### HISTORIC AND DESIGN REVIEW COMMISSION June 17, 2020

HDRC CASE NO: 2020-152

**ADDRESS:** 2158 W KINGS HWY

**TYPE OF WORK:** Enclosure of front porch with windows and door

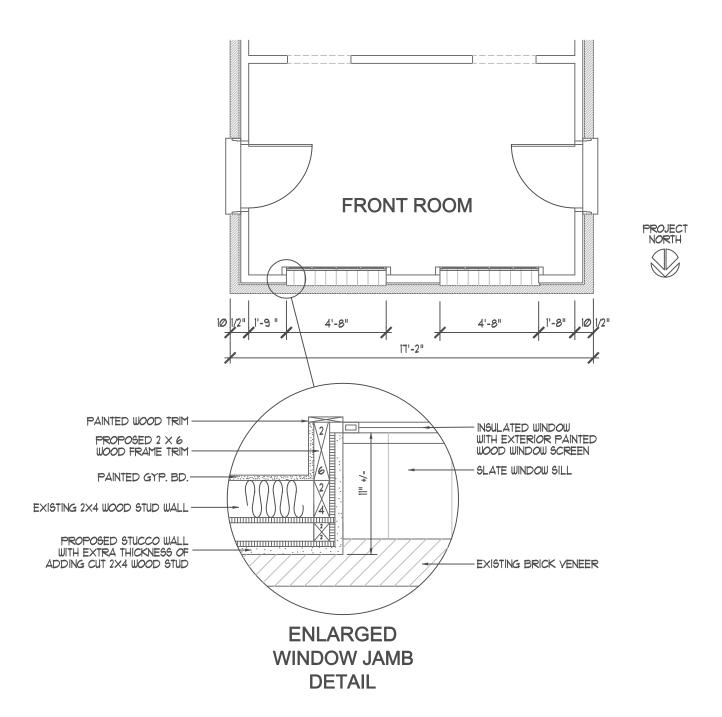
We are proposing to install two rectangular windows the same width of the previous openings, with a brick base across the front. Above the brick base, we are proposing to install a matching stucco color and smooth finish with dark wood banding and "Tudor" style quarter round corner detailing, as shown on the attached perspective sketch. We are also going to reinstall a "boxed hedge" shrub across the front elevation that previously existed.

The window will be recessed in the walls by the extra thick stucco wall and have a thin, slate sill, and be covered with a matching dark color wood frame with a 3" perimeter dimension and interior 1" mullions. We don't want to reintroduce the stucco arches above the windows since it would be a false interpretation of the arches above the windows and would be architecturally inappropriate.

## Drive way Side. Door & Side lites added

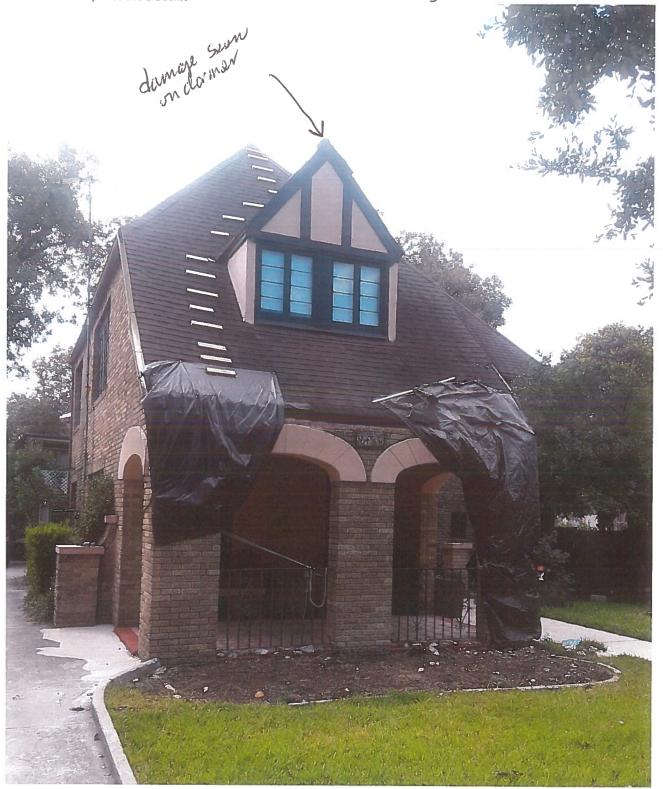
add cirved picture windows in arched opening. Follow the distinct characteristics or in the window framings - Keep Frontails -

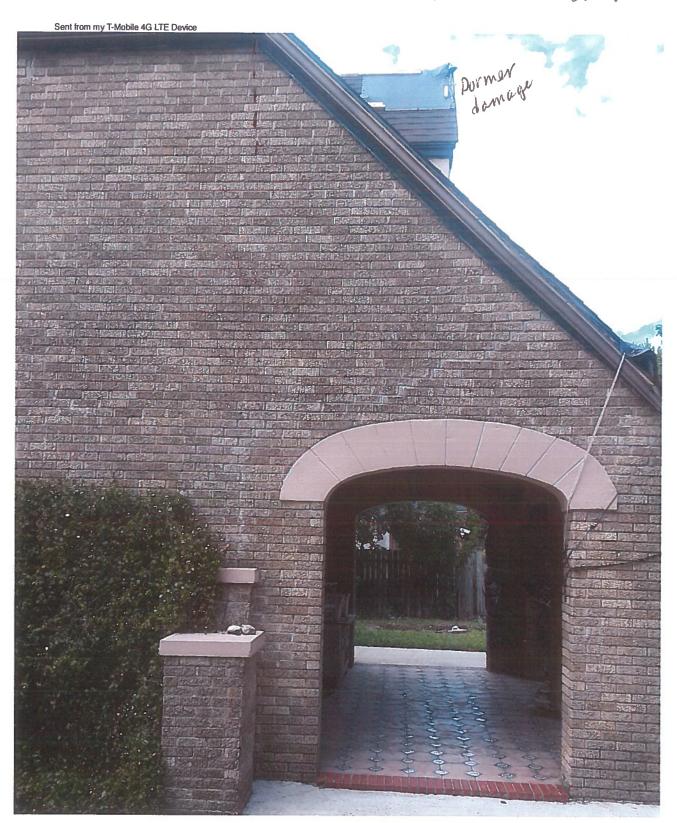
Side Walk/ Front door side Similar to drive way side Widummy" door

Keep the distinct characteristic- side of the front door in the driveway door i waij
